Québec–New Hampshire Interconnection

**Hydro-Québec TransÉnergie (HQT) responses to the National Energy Board's Request
for Information **No. 2** dated July 10, 2017**
July 24, 2017

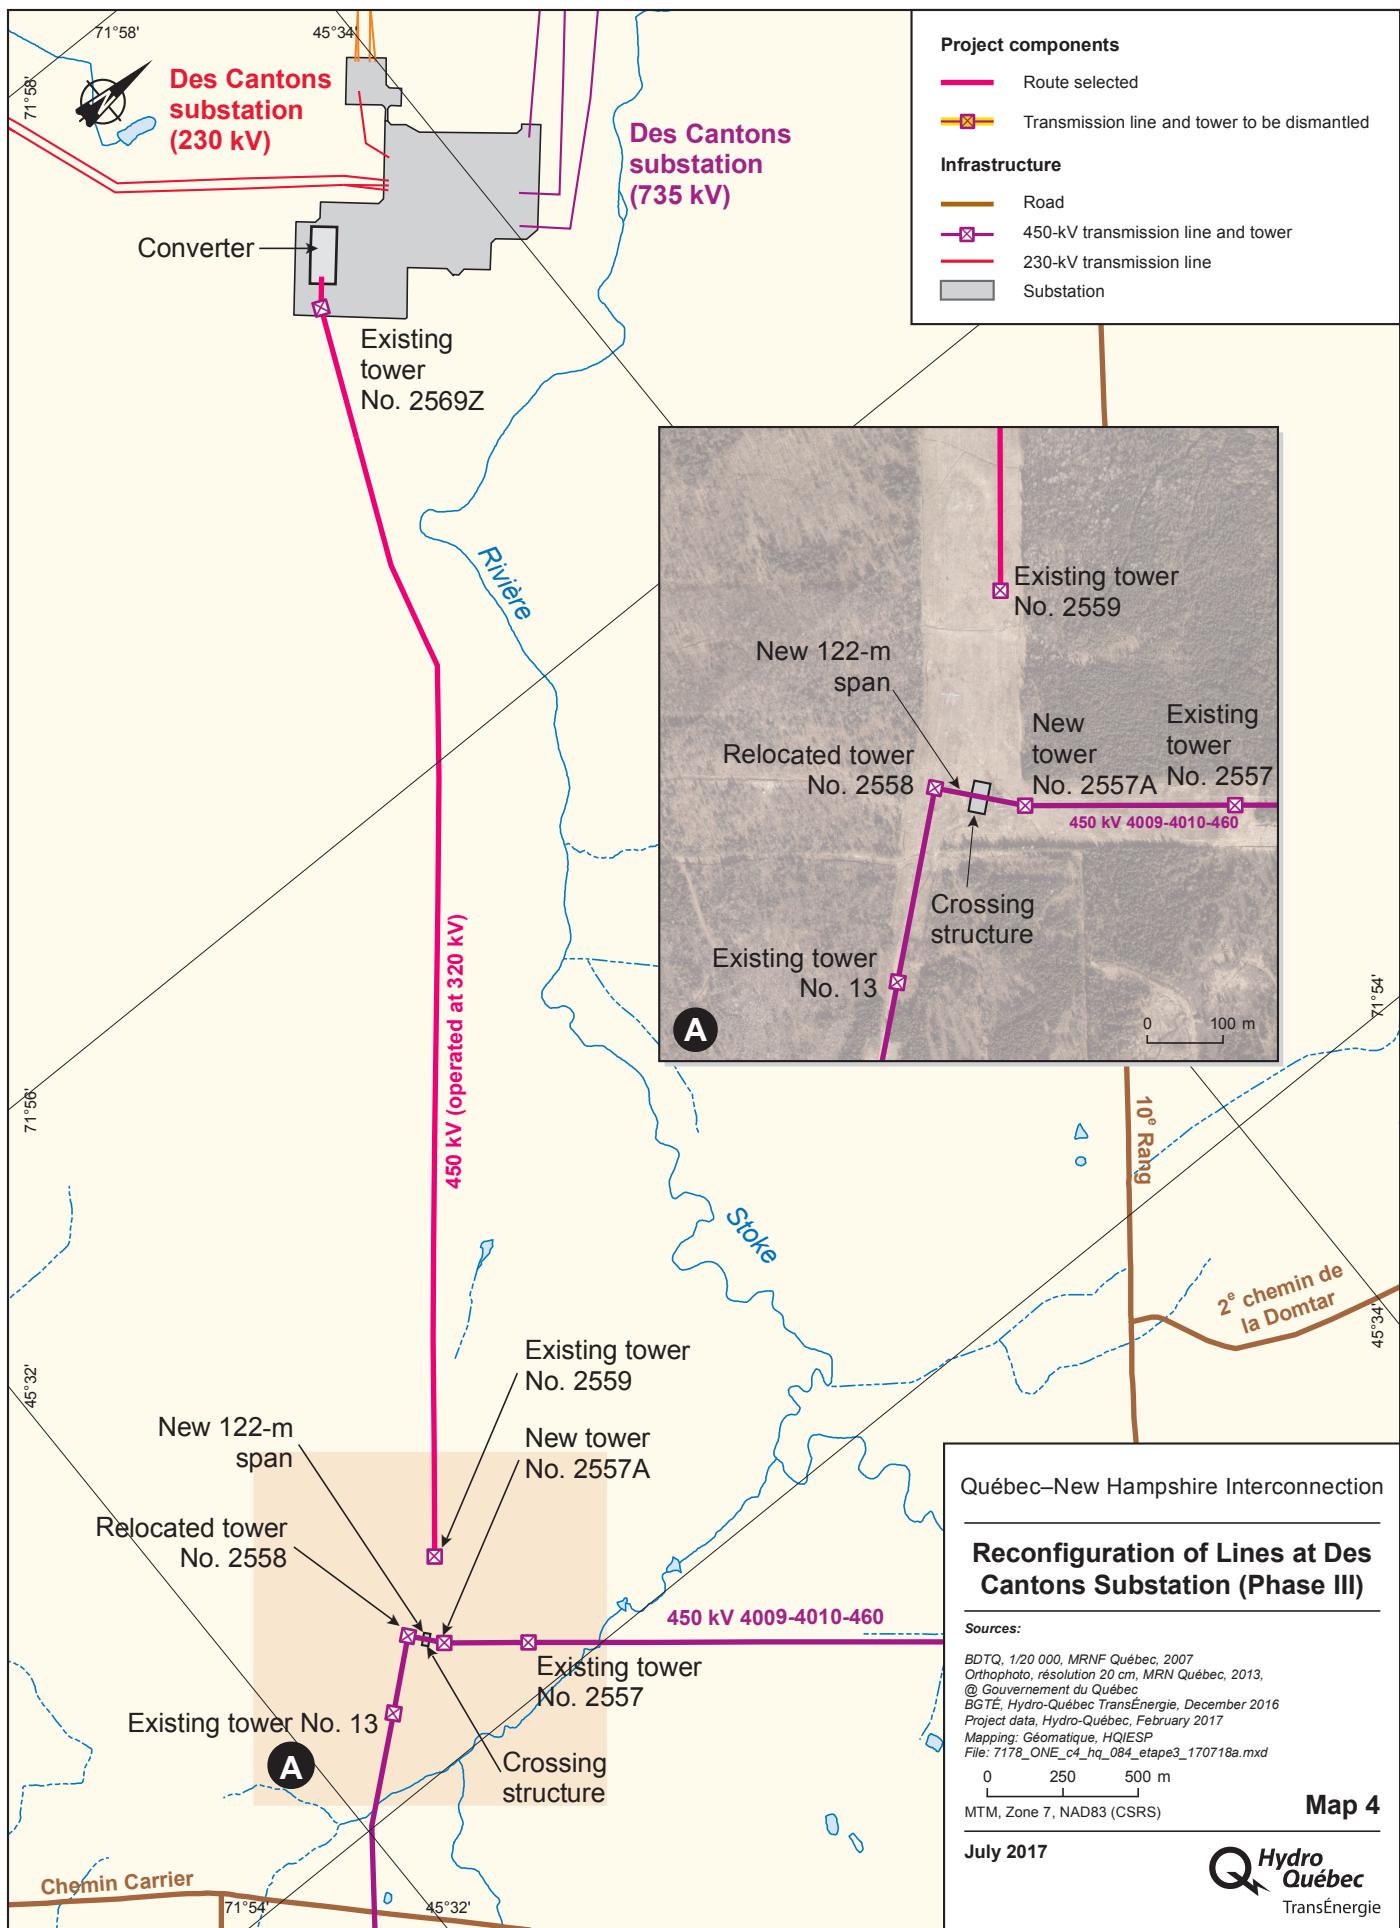
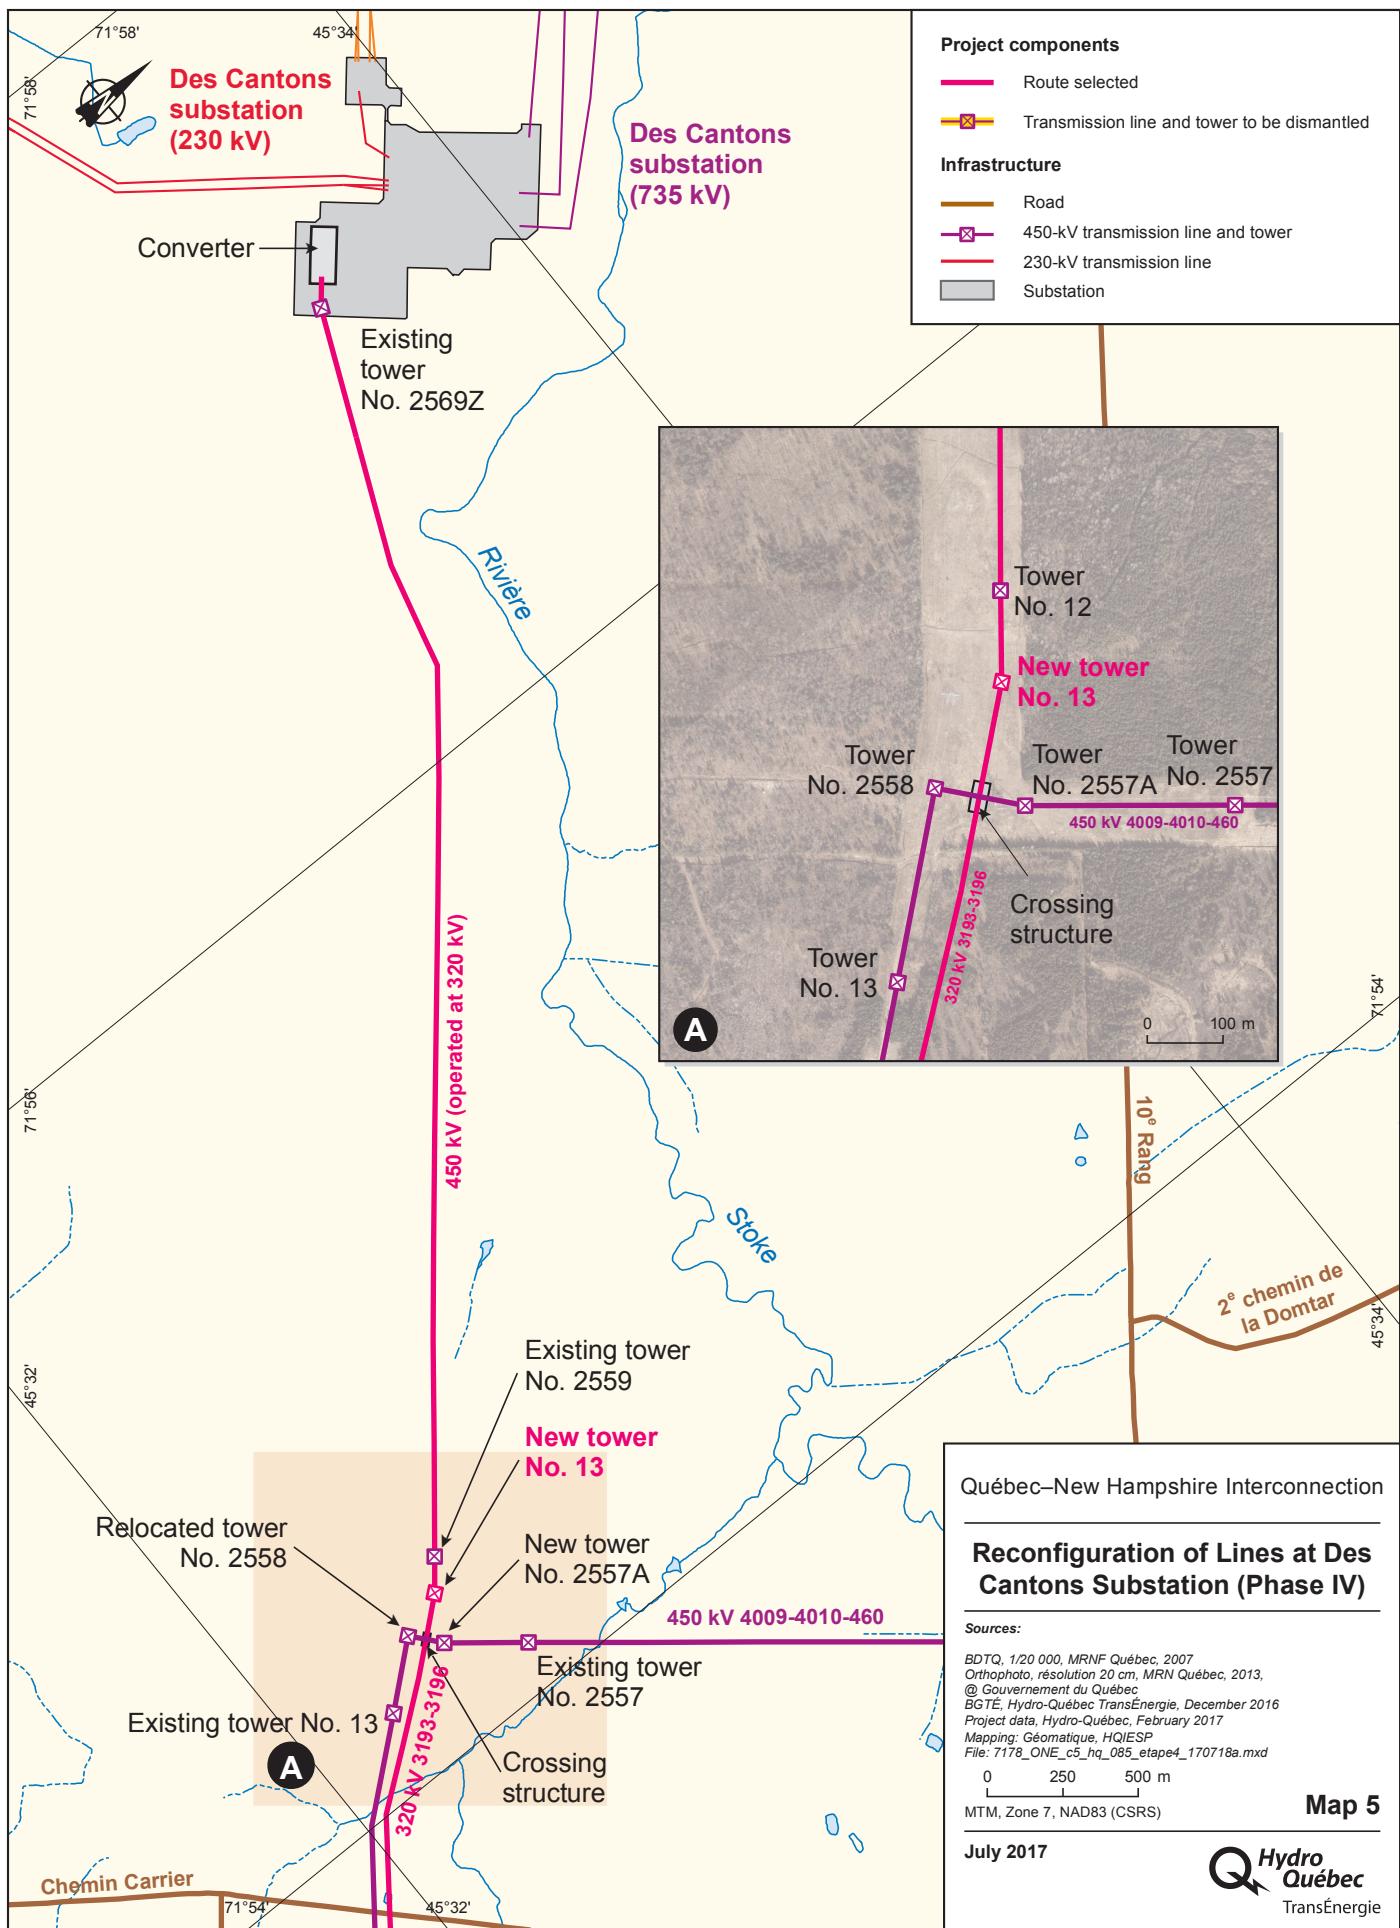
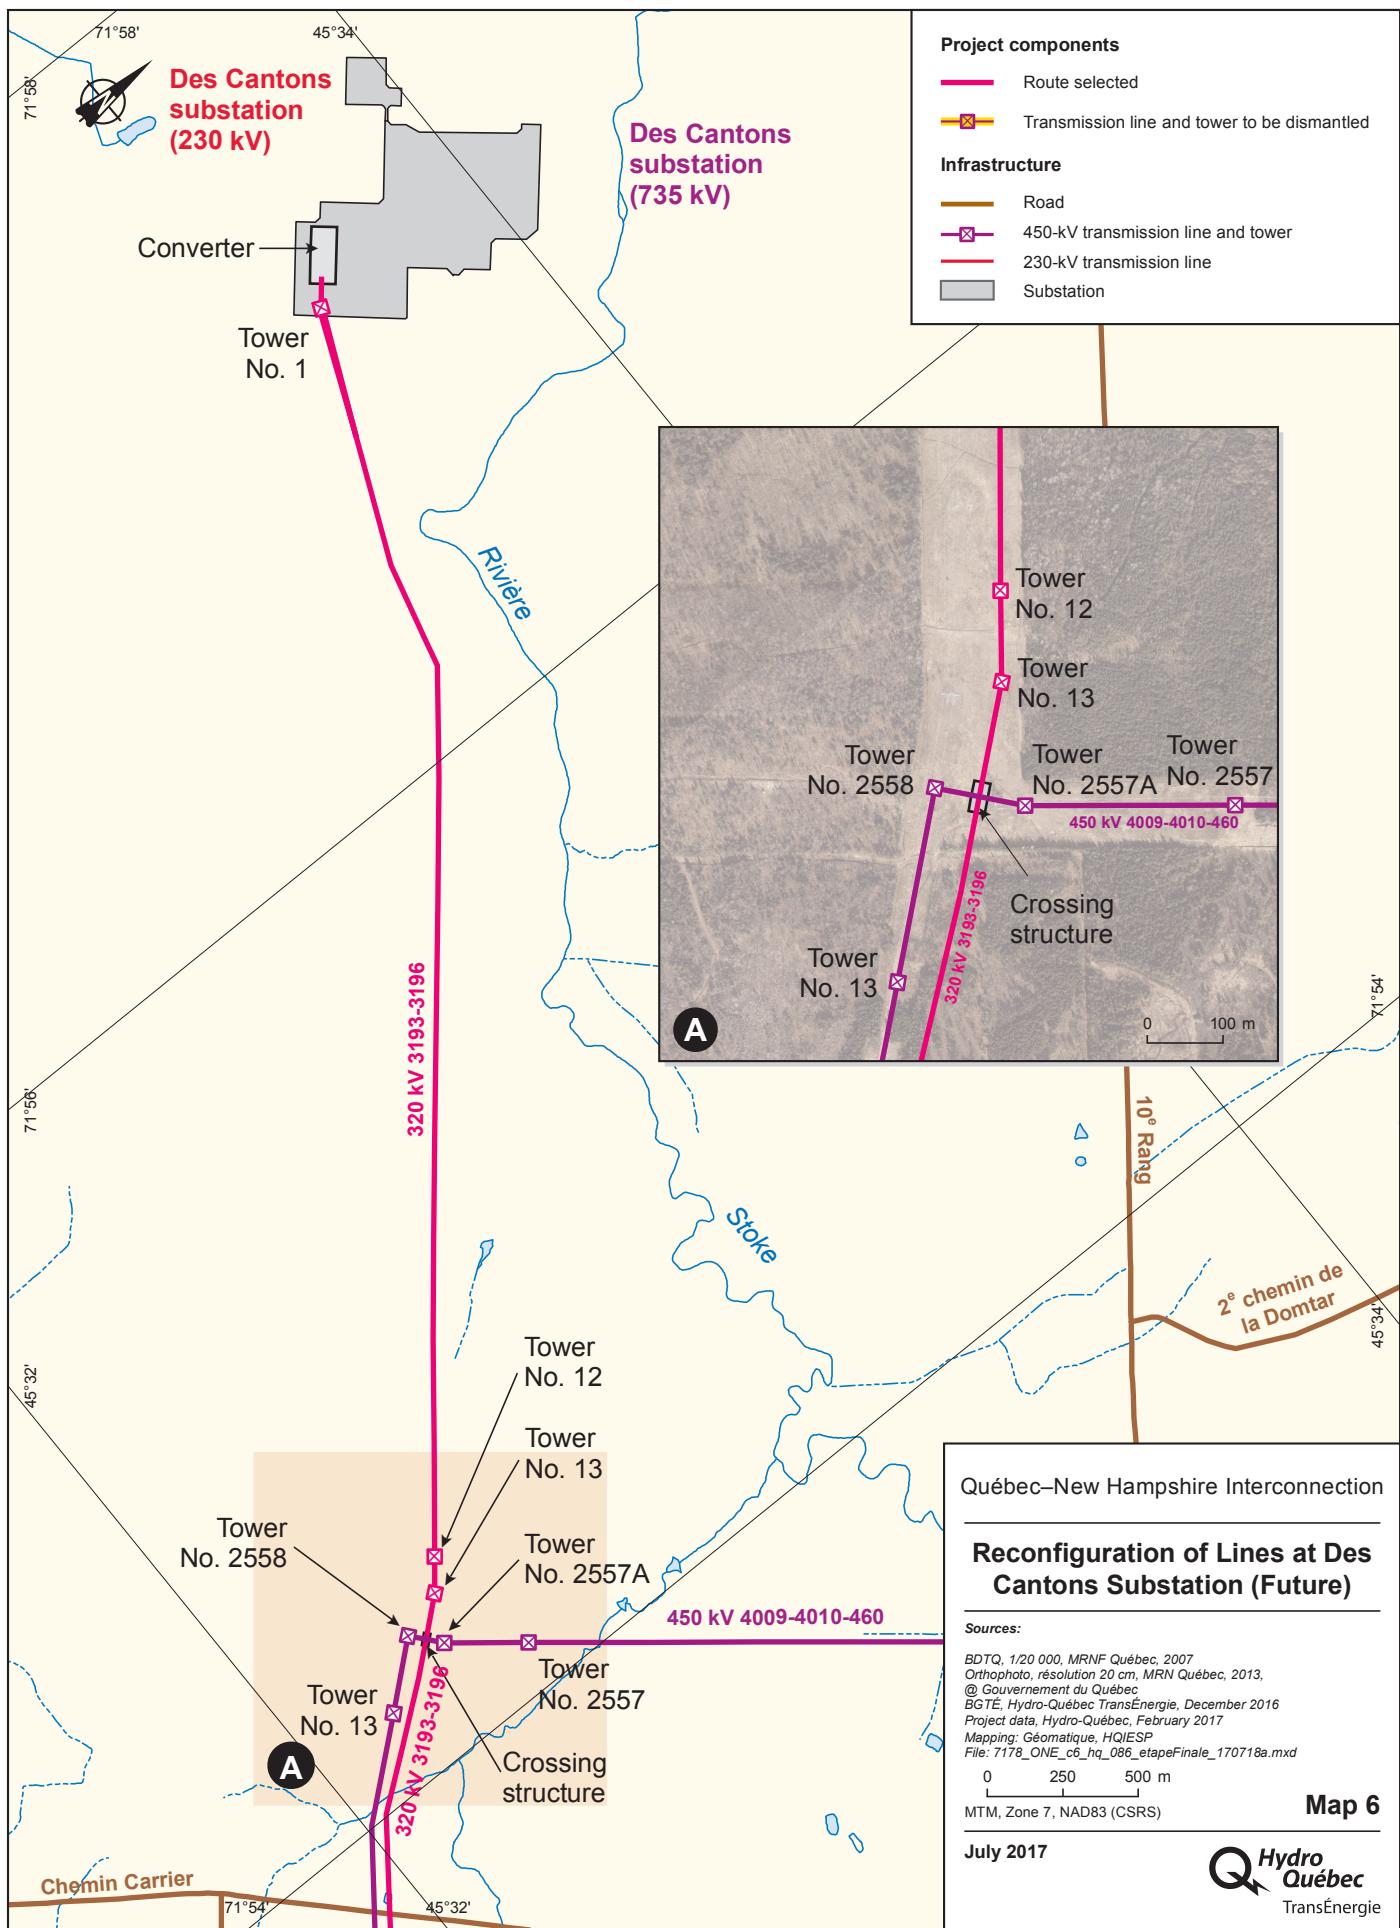
- b) Revised Figures 1 through 5 in Reference iii), showing the numbering (labels) of all the towers.

Answer 2.3 b) *Maps 1 through 6 below show the various construction phases for the planned IPL, with all towers clearly labeled with their respective numbers.*
